Re: Consistency Determination of the Dominican Valley Housing Project Development Application (PLAN23-081; ED23-062; TS23-001) at APN 015-163-03

Date: August 12, 2024
To: Sarah Teplitsky, City of San Rafael
From: Neil Smolen & Bob Grandy, Fehr & Peers
Subject: **Dominican Valley TIS Peer Review**

SUBJECT: PLAN23-081 – Dominican Valley – 4th Review

TENTATIVE MAP
DOMINICAN VALLEY SUBDIVISION
APN: 015-163-03
CITY OF SAN RAFAEL, MARIN COUNTY, CALIFORNIA
APRIL 2024

PRELIMINARY STORMWATER CONTROL PLAN-2
DOMINICAN VALLEY TENTATIVE MAP (A.P.N. 015-163-03)
CITY OF SAN RAFAEL MARIN COUNTY CALIFORNIA

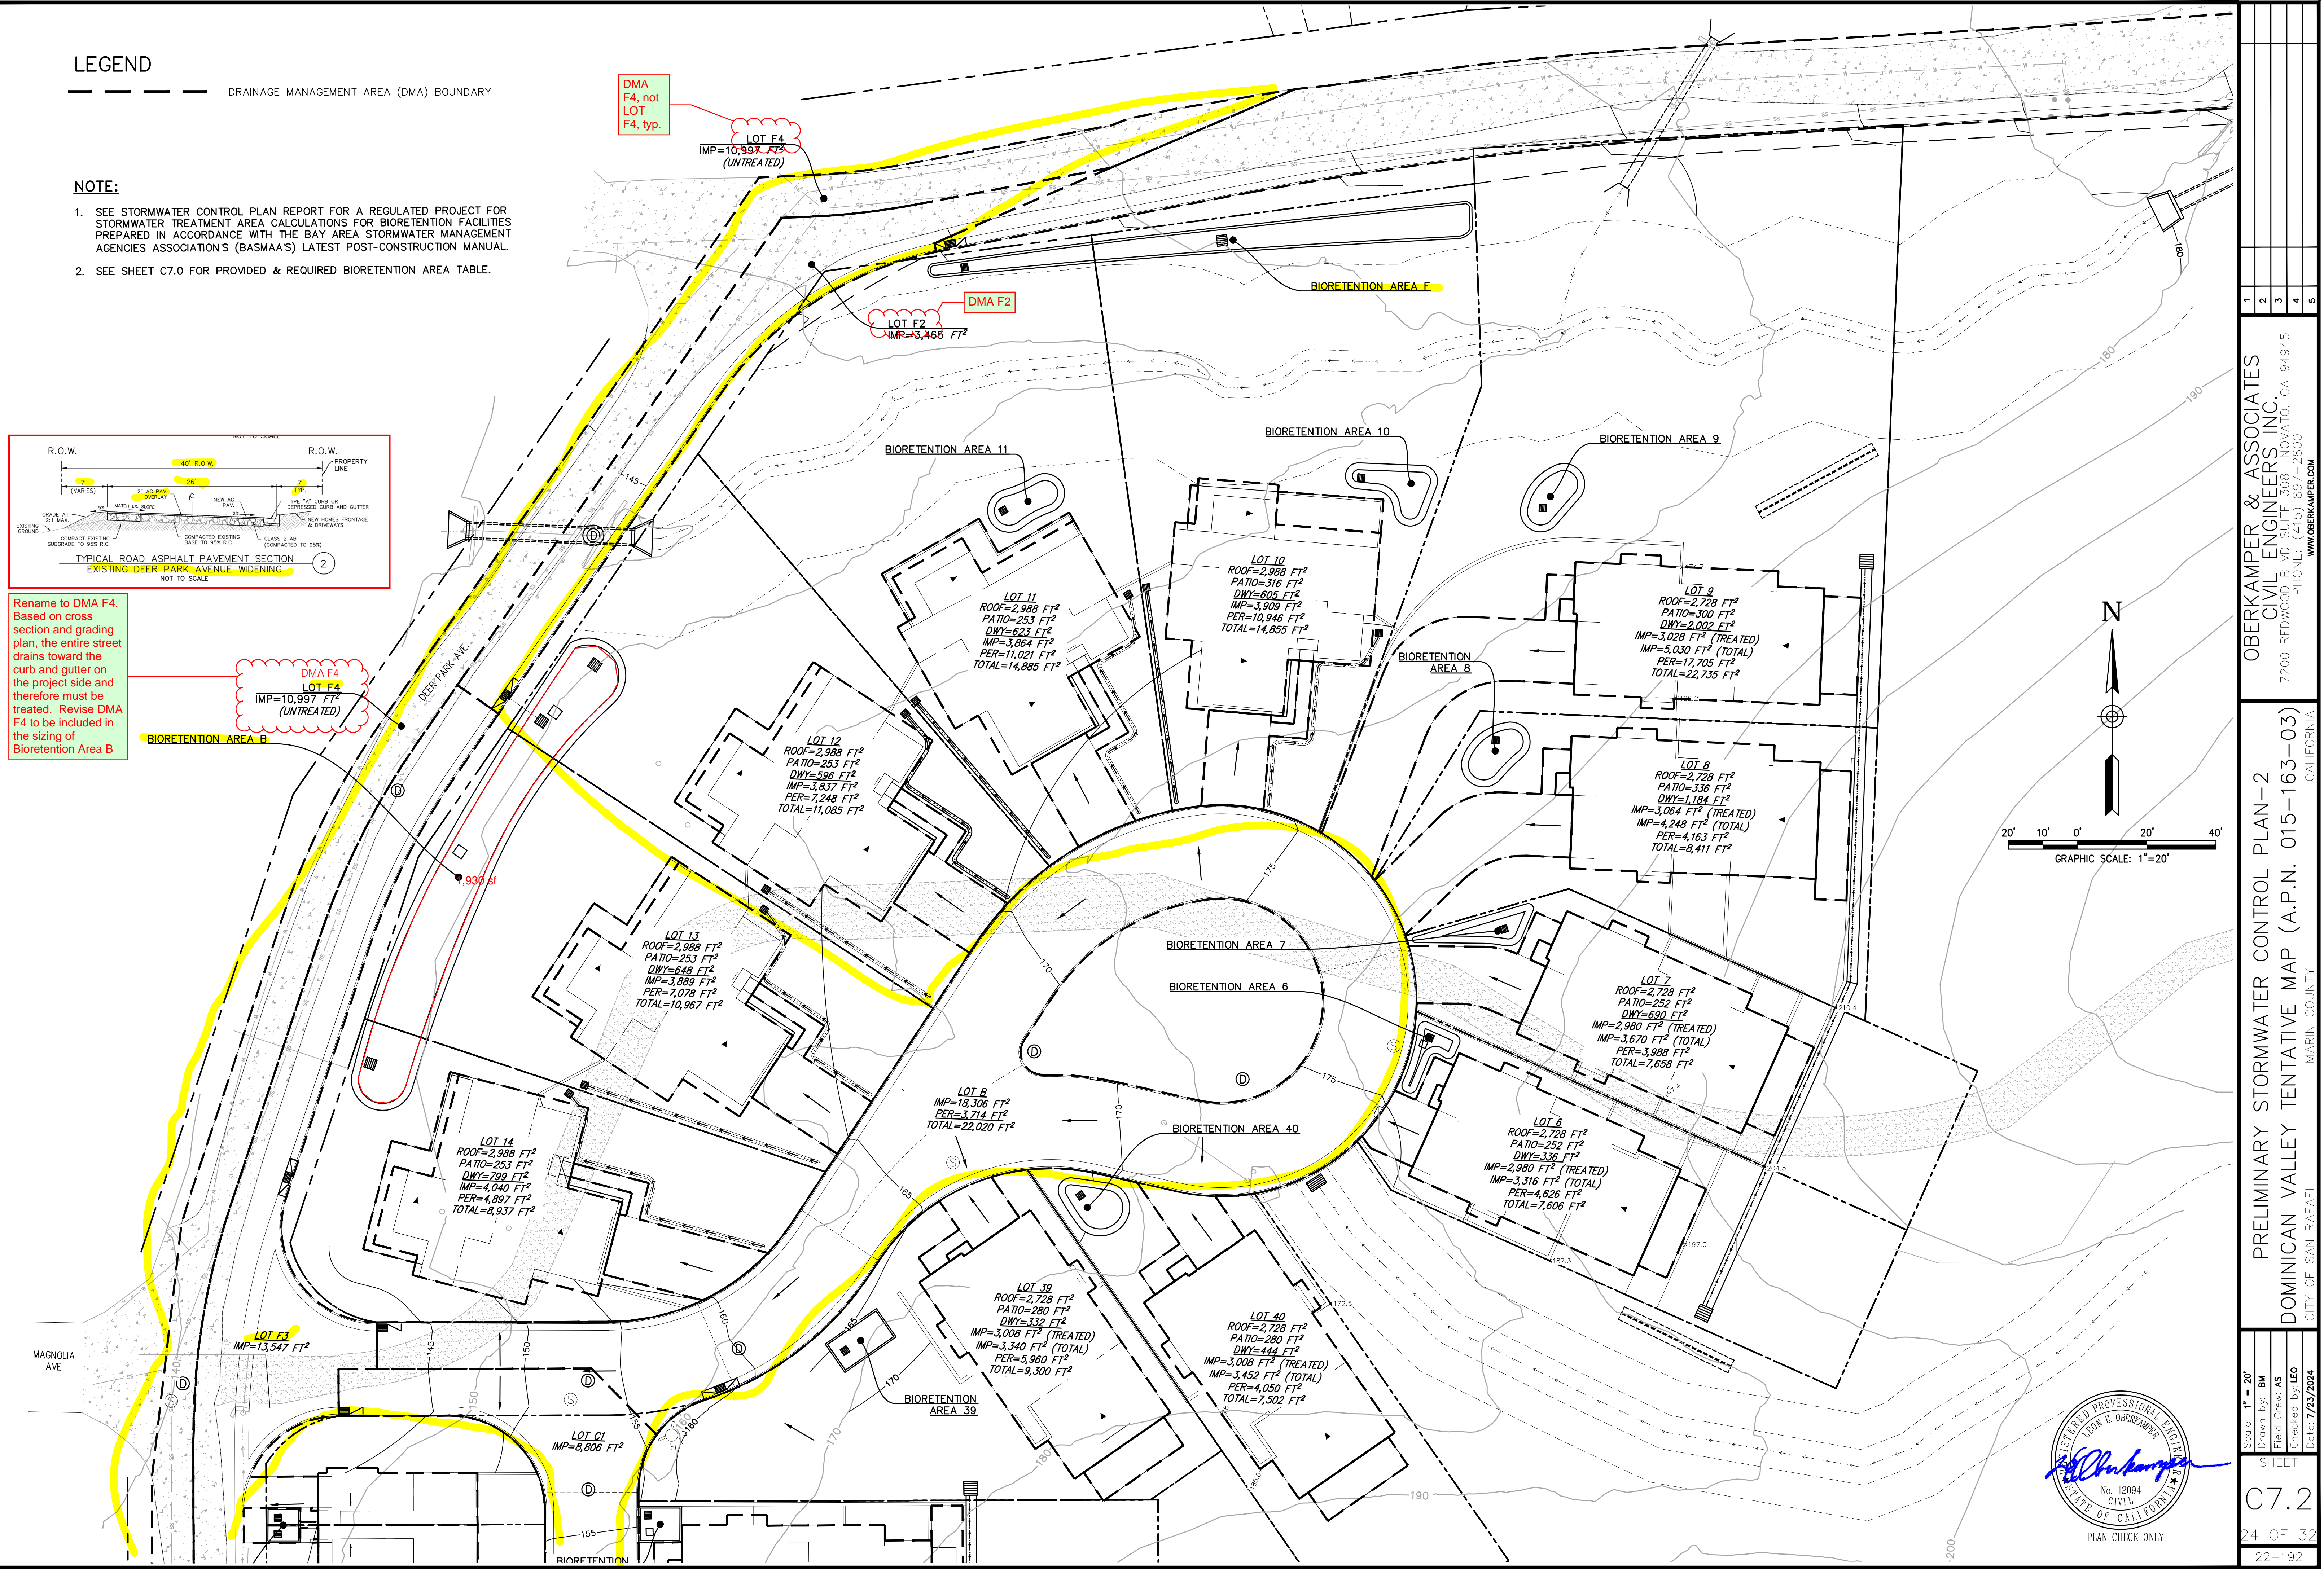
- d. Rename Lot F4 to DMA F4. Based on the typical cross section at Deer Park Avenue, the entire street drains toward the curb and gutter on the project side and therefore must be treated. Revise DMA F4 to be included in the sizing of Bioretention Area B.

Rename to DMA F4. Based on cross section and grading plan, the entire street drains toward the curb and gutter on the project side and therefore must be treated. Revise DMA F4 to be included in the sizing of Bioretention Area B
